**18-2024**25 January
2018**TECHNICAL SERVICE BULLETIN**
Lack Of Heat - Blower Motor Frozen - Cold Weather Conditions

This bulletin supersedes 16-0018. Reason for update: Concern Carryover to New Model

Ford 2011-2017 Fiesta

Figure 1

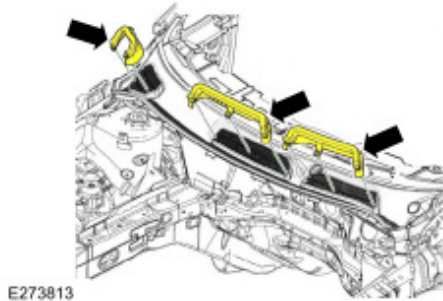
- (1). Yes – refer to Workshop Manual (WSM), Section 412-00 for normal diagnostics.
 - (2). No - proceed to Step 2.
- 2.** Replace the cabin air filter. Refer to WSM, Section 412-00.
- 3.** Open the hood and inspect for the presence of foam deflectors on the air inlet openings of the cowl opening grille. (Figure 1). Are deflectors present?
- (1). Yes – remove and discard the foam deflectors. Proceed to Step 4.
 - (2). No - proceed to Step 4.
